Docket Number:	21-SIT-01
Project Title:	21-SIT-01, SB100 Implementation Planning for SB100 Resource Build
TN #:	250960
Document Title:	Comments of the Large-scale Solar Association on Resource Portfolios for the 20-Yr Tx Outlook
Description:	N/A
Filer:	System
Organization:	Large-scale Solar Association
Submitter Role:	Public
Submission Date:	7/7/2023 8:52:36 AM
Docketed Date:	7/7/2023

Comments of the Large-scale Solar Association Regarding Resource Portfolio Assumptions for the Next CAISO 20-Year Transmission Outlook

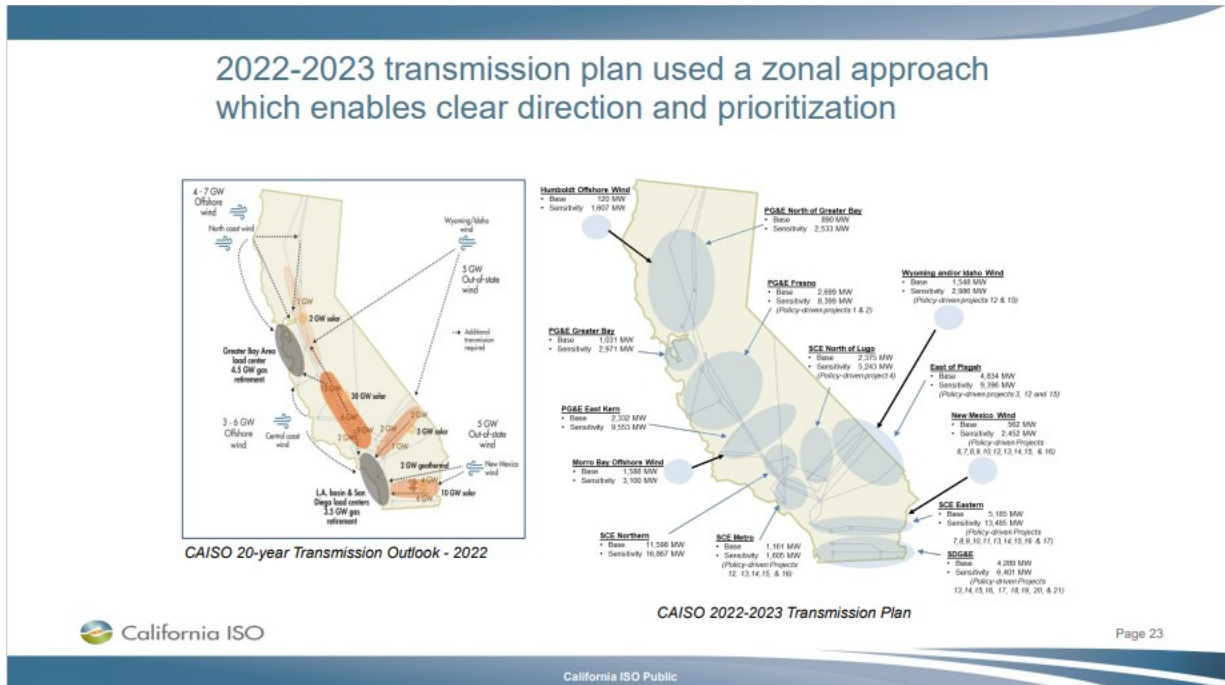
CAISO's 2022-23 transmission plan was the first to use a zonal approach, which divides the region into 14 zones, each with its own forecasted resource need. For example, CAISO has indicated that the PG&E Fresno area will require 8,399 MW¹ of new resources. LSA supports this approach and the transparency it provides, and we are encouraged to see that CAISO will continue to use it for the next 20-Year Transmission Outlook.

The California Public Utilities Commission (CPUC) is also using geographic zones in its busbar mapping process to develop the portfolios for the 20-Year-Transmission Outlook. However, the zones used by the CPUC do not match the boundaries or naming conventions used by CAISO (see slides below). For

example, the CPUC maps solar and battery storage to a zone in southern California called “Riverside”² and CAISO refers to a larger zone in the same area as “SCE Eastern”.³ LSA encourages continued use of the zonal approach but urges the state regulatory entities to find alignment across the planning processes by using the same metrics and the same zones. If using different geographic zones is necessary at different points during the busbar mapping process to allow for more granularity, the information should ultimately be compiled into zones that are consistent between the resource and transmission planning results. This consistency will give stakeholders more confidence in the linkages between these two processes, which will have the intended result of driving market behavior aligned with the results.
